Metal Junction Box Grounding Instructions

Bulletin Type:	Recall	Publication Date:	March 2022
Bulletin #(s):	22V-057	Make(s):	Highland Ridge RV
Job Code(s):	9904574	Model(s):	Olympia, Olympia Sport
Flat Rate(s):	.50 / Hour	Model Year(s):	2022

Incident:	Metal junction box was not grounded
Affected Units:	2022 Olympia, Olympia Sport
Parts List:	Parts List: (Purchase locally) - MN cable (Copper Wire)
	Parts Kit Contents: None
Misc. Tools & Supplies:	- Flathead Screwdriver - Wire Pliers/strippers

FIG 1

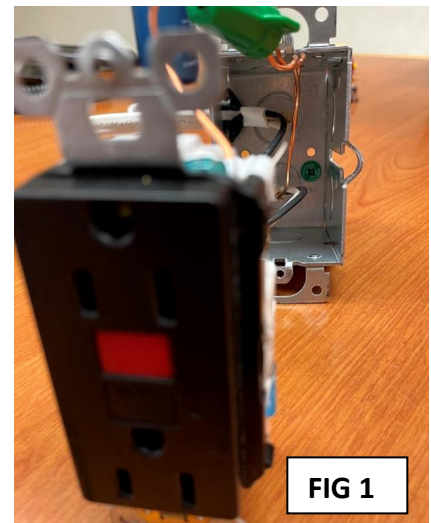
1. Disconnect unit from the 120V power source
2. Locate metal junction box with a GFCI receptacle at the **Bathroom** for the *Olympia*.
3. Locate metal junction box with a GFCI receptacle at the **Kitchen** for the *Olympia Sport*.
4. Remove faceplate and receptacle (Fig. 1) to expose wires.

FIG 2

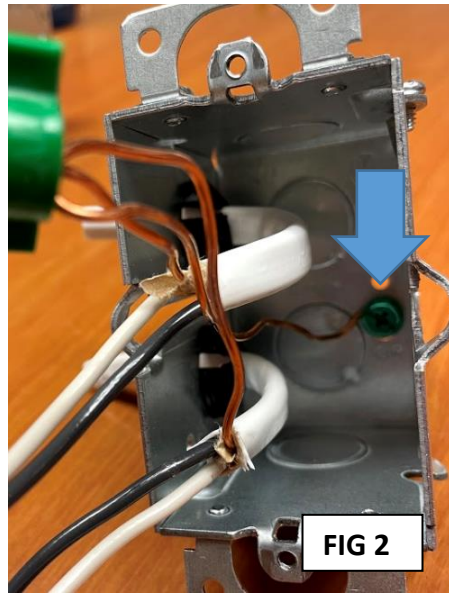
5. Install and secure a separate bare ground wire of sufficient length at the green ground screw (Blue Arrow) in the metal junction box (Fig 2).

FIG 3

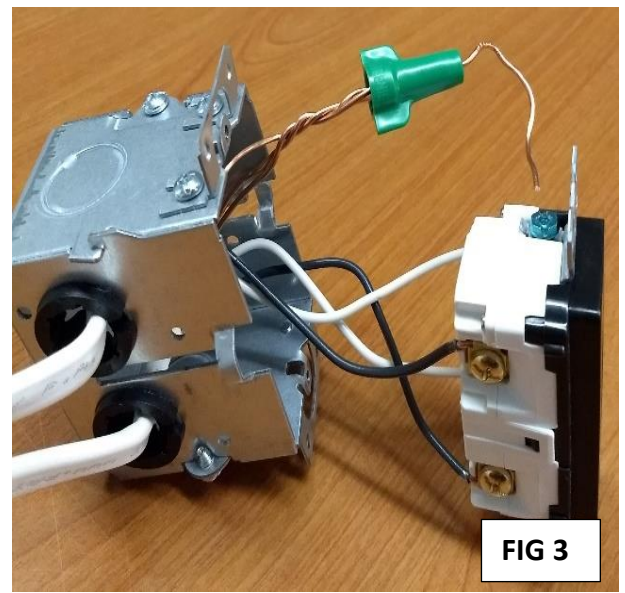
6. Connect all ground wires together with green wire nut. Ensure the bare ground wire attached to the box passes through the hole in the top of the green wire nut (Fig 3).
7. Connect the bare ground wire coming through the top of the wire nut to the green ground screw (Green Arrow) on the GFCI receptacle (Fig 4).
8. Insert wires back into the metal junction box.
9. Secure GFCI receptacle and outlet face plate to junction box.
10. Turn power back on and validate function of the GFCI receptacle.
11. Repair is complete.
